SOQUEL APTOS GROUNDWATER MANAGEMENT COMMITTEE (SAGMC)

AGENDA

To: Ron Duncan, Soquel Creek Water District
From: Cameron Tana
Cc: Ralph Bracamonte, Central Water District
Rosemary Menard, City of Santa Cruz
John Ricker, County of Santa Cruz
Date: January 15, 2016
Subject: Santa Cruz Mid-County Basin Boundary Modification Update

Santa Cruz Mid-County Groundwater Basin Boundary Modification

Figure 1. Alternative Boundary Modification for Santa Cruz Mid-County Basin

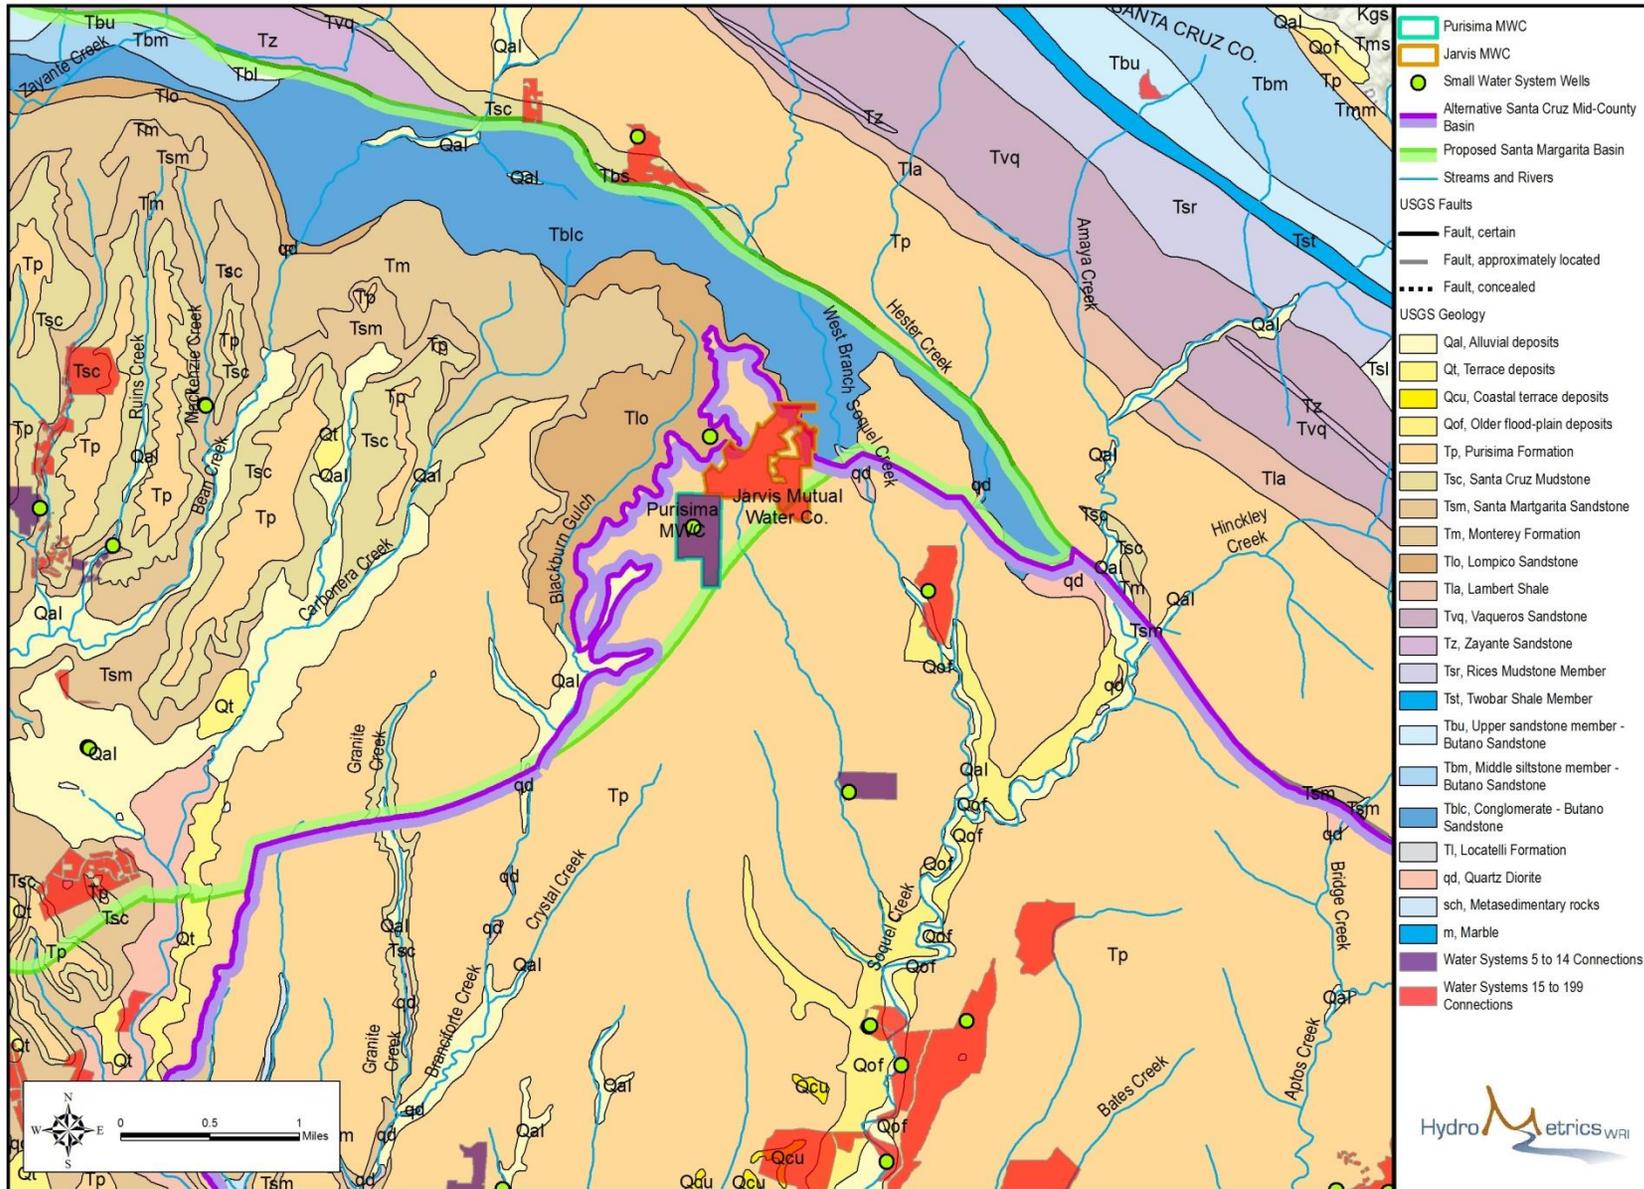
As discussed in the draft response to comments in Appendix F, the Santa Margarita Basin being proposed by Scotts Valley Water District (SVWD) is based on the extent of the underlying Lompico and Butano Formations, stacked aquifer units that provide water supply for SVWD and other pumpers to the west, and therefore fits the definition for groundwater basins in Bulletin 118. However, we acknowledge that production from shallow or marginal areas of the Purisima Formation in the area of the proposed shared basin boundary may be associated with groundwater of the shared resource of the Santa Cruz Mid-County Basin. In this area where aquifers for the two basins overlap, it is reasonable that pumping from the shallower Purisima Formation by Purisima Mutual Water Company affects the water budget of the Mid-County Basin more than the Santa Margarita Basin. Therefore, there is justification for including the area in the Mid-County Basin, especially since there is no other public water system

Given this reasonable justification and Purisima Mutual Water Company's strong preference to be a part of the Santa Cruz Mid-County Basin instead of the Santa Margarita Basin, an alternative boundary modification is presented in Figure 1 for SAGMC consideration. The alternative boundary modification reflects pumping in the shallow Purisima Formation in the area of Purisima MWC by including in the Santa Cruz Mid-County Basin the outcrop of the Purisima Formation in this area east of the Lompico Formation outcrop around the Blackburn Gulch and west of the Lompico and Butano Formation outcrops near West Branch Soquel Creek.

SVWD is scheduled to consider this alternative boundary on January 14, 2016. Agreement between SAGMC and SVWD on this shared boundary is highly recommended before submittal of the modification requests to DWR.

Figure 1: Proposed Santa Cruz Mid-County Basin Boundary Modification

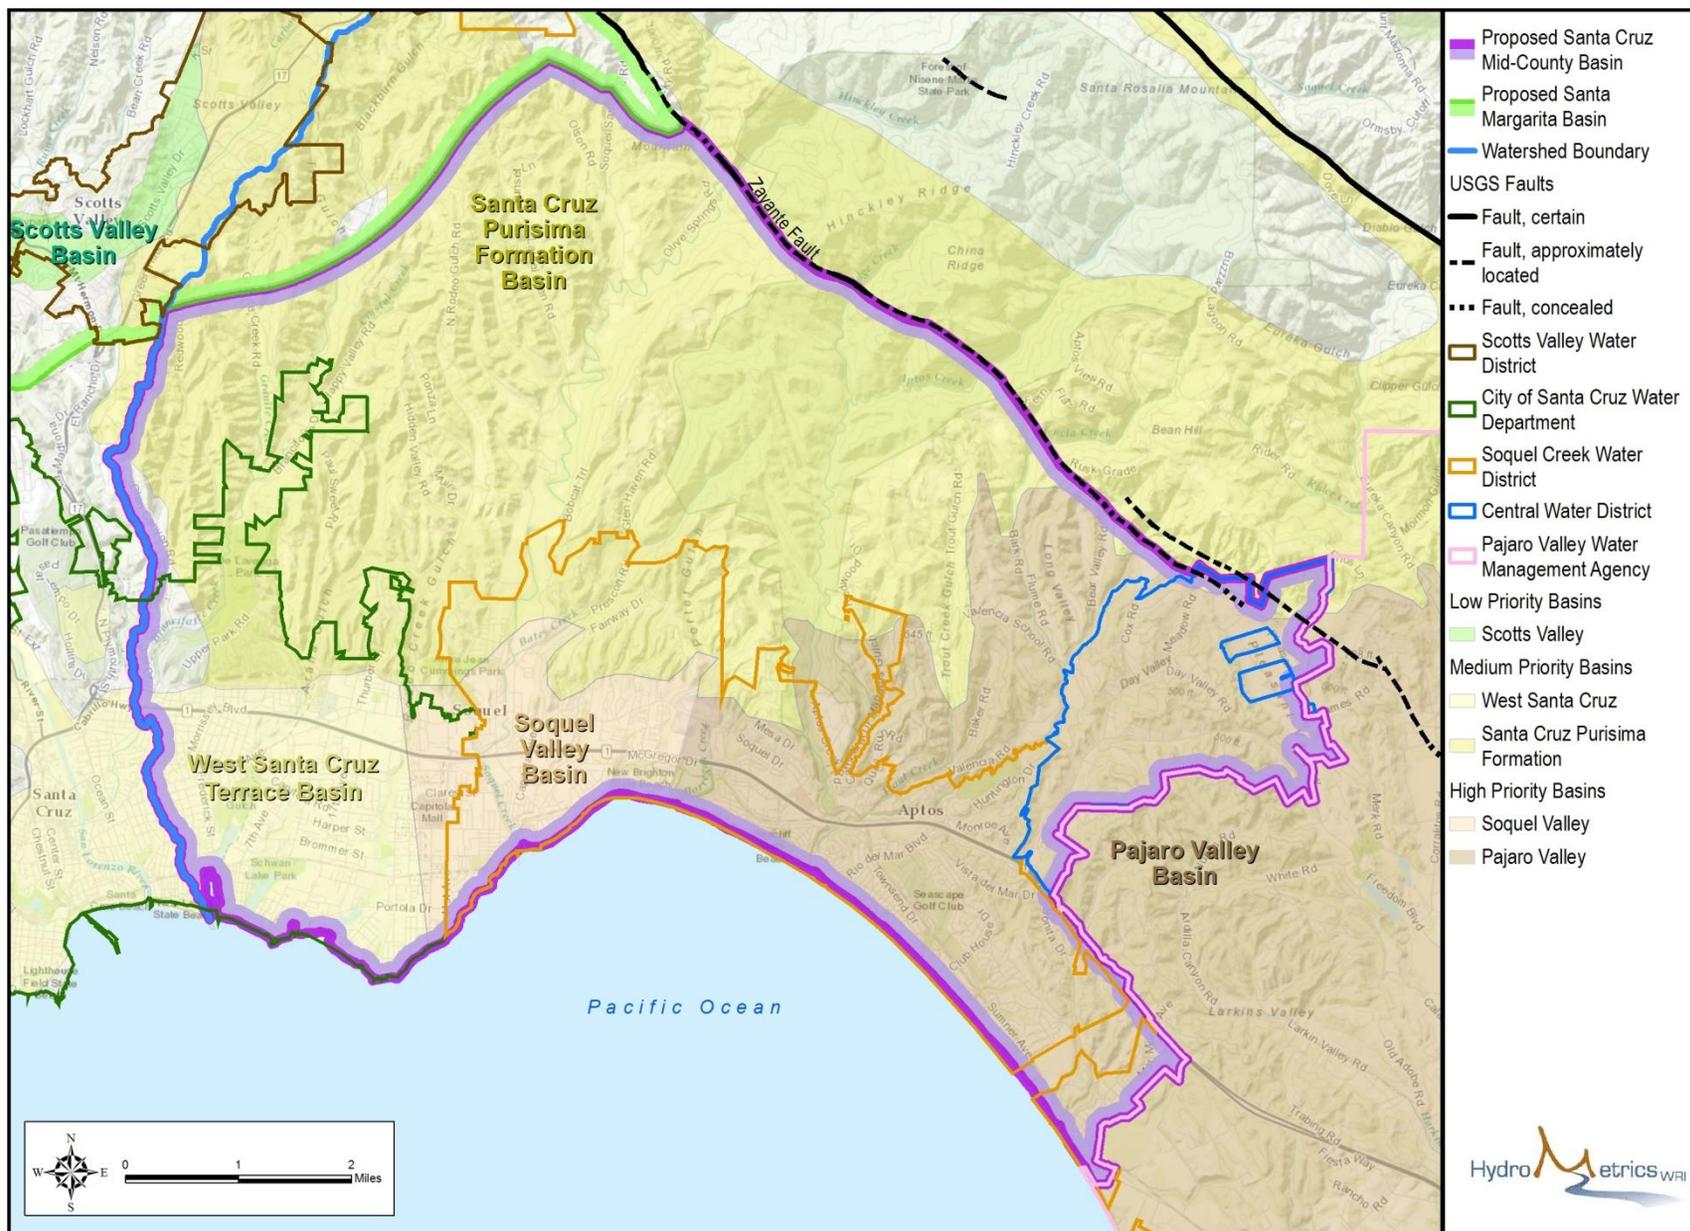
Fourth, the present Scotts Valley Basin boundary as shown in Figure 1 of the Mid-County report is the logical geological boundary between the Santa Margarita and Santa Cruz Purisima Formations. Shifting this boundary as proposed would not produce a "cohesive basin" as stated in the Scotts Valley report, but rather fragments the basins.

Point 5-4: "...the present Scotts Valley Basin boundary as shown in Figure 1 of the Mid-County report is the logical boundary between the Santa Margarita and Sanat Cruz Purisima Formations."

Figure 5: Recharge Areas in Santa Cruz Mid-County Basin

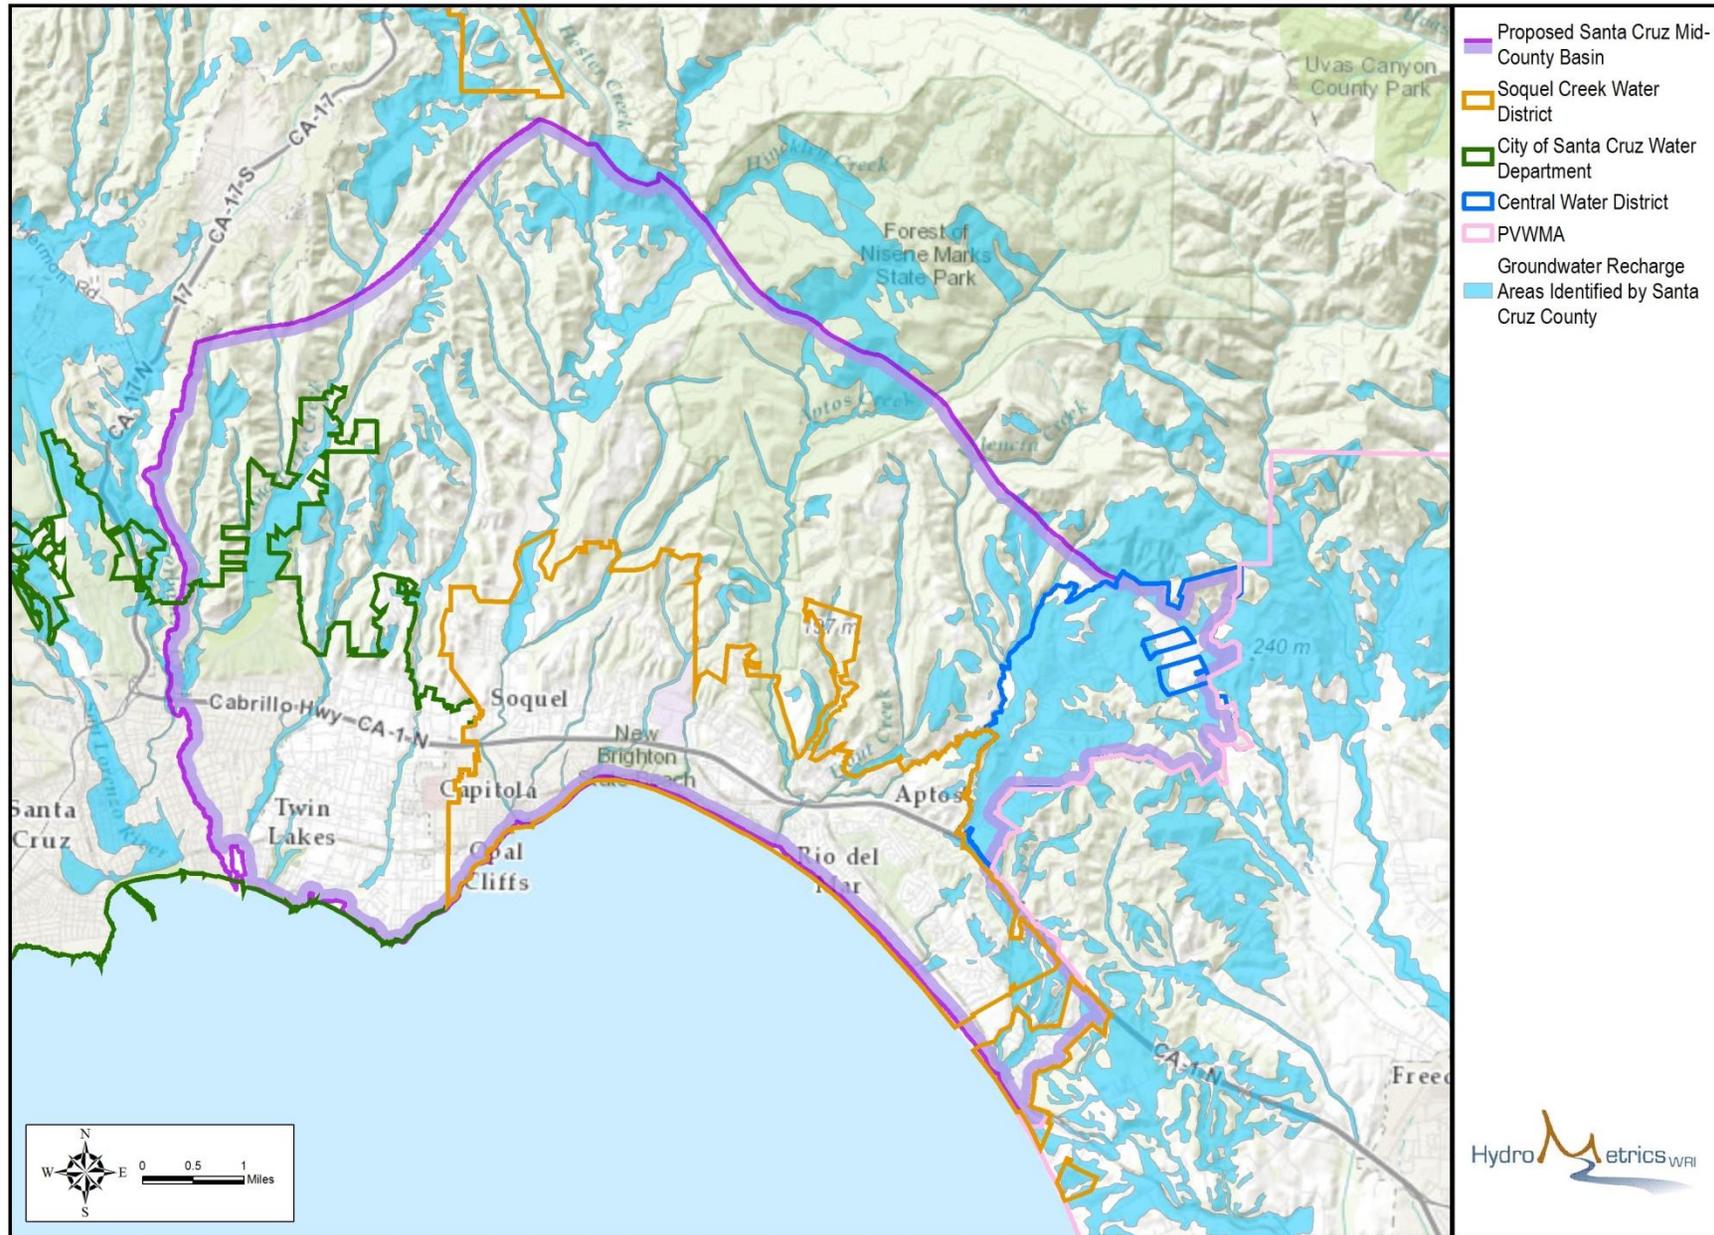
Sixth, the map showing recharge areas for the Mid-County basin (see Figure 5 of the Mid-County report) and topographic maps that can be used to map drainage basins indicate that both recharge and drainage in the Purisima Mutual Water Company area lie within the Santa Cruz Purisima Formation Basin. It makes no logical sense to separate drainage and recharge areas from one basin to another.

Figure 11: Groundwater Management Area and Proposed and Existing DWR Basins

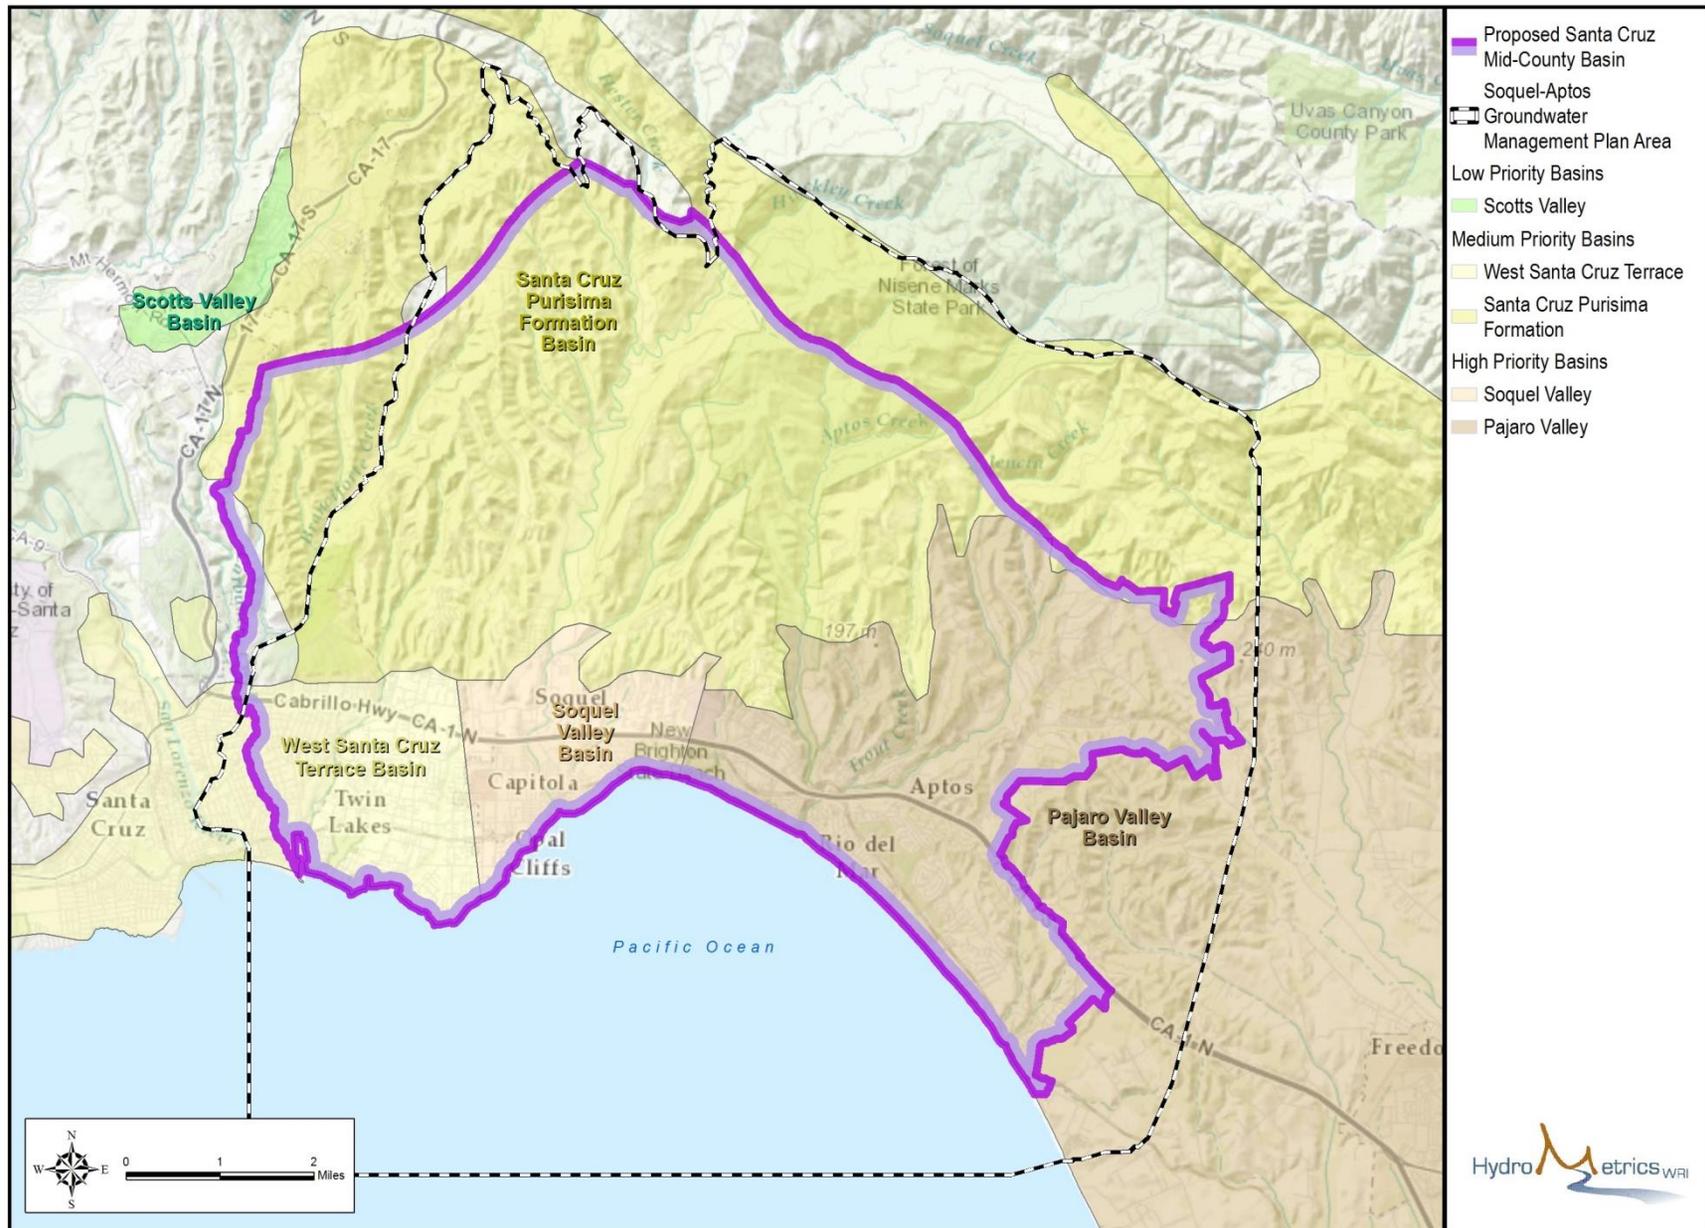
Fifth, the Soquel-Aptos Groundwater Plan Management Area shown in Figure 11 of the Mid-County report makes much more sense as a basin boundary than that proposed by Scotts Valley report. The smooth arc-like change shown for the proposed boundary adjustment makes no geological sense and leaves one wondering if the proposed shift is the result of a GIS effort with limited or no geological or hydrological input.

Figure 3: Santa Margarita Groundwater Basin Lateral Boundaries (geology from Brabb et al., 1997)

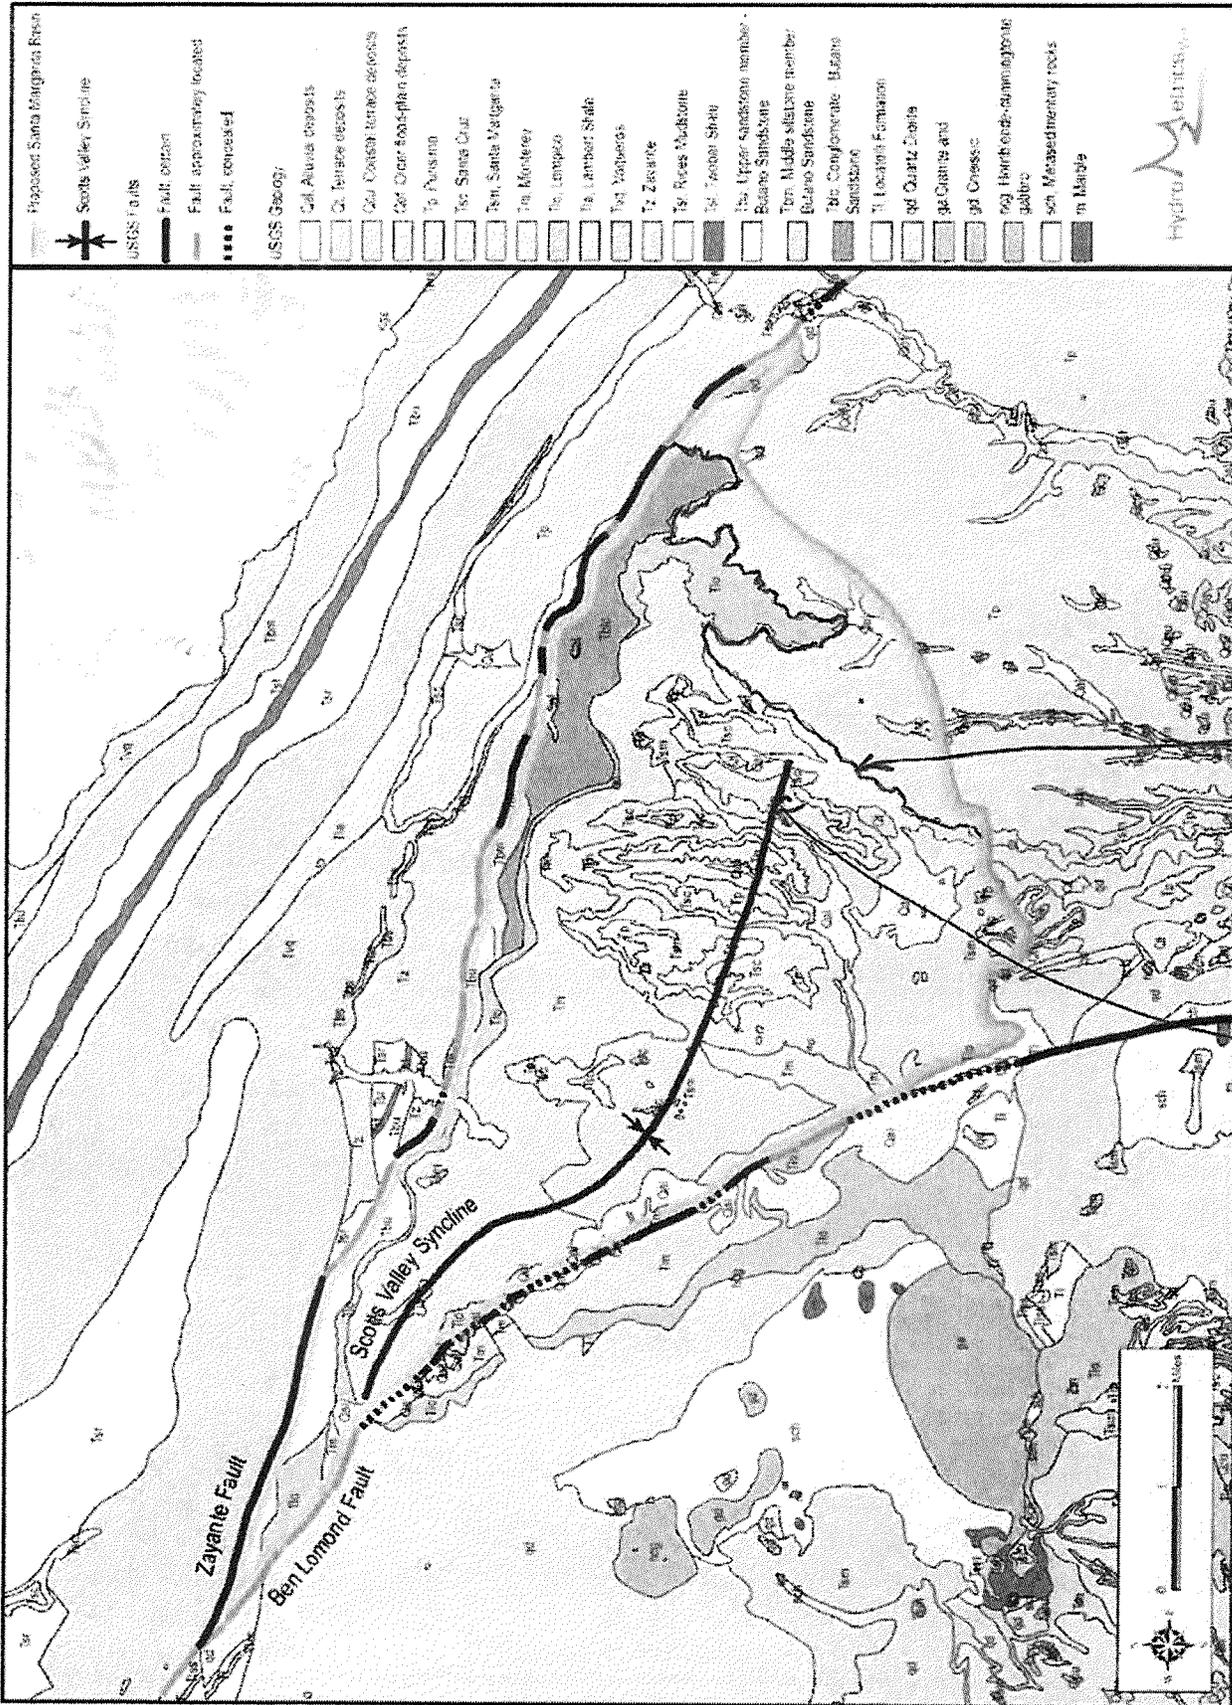
First, a natural mapped geologic boundary exists between the older Miocene Santa Margarita Formation and the most contiguous part of the Pliocene Purissima Formation. This boundary lies basically along lower Jarvis Road in Blackburn Gulch with the Purissima located to the southeast of the road and Santa Margarita to the northwest (see attached modification of Figure 3 from the Scotts Valley report).
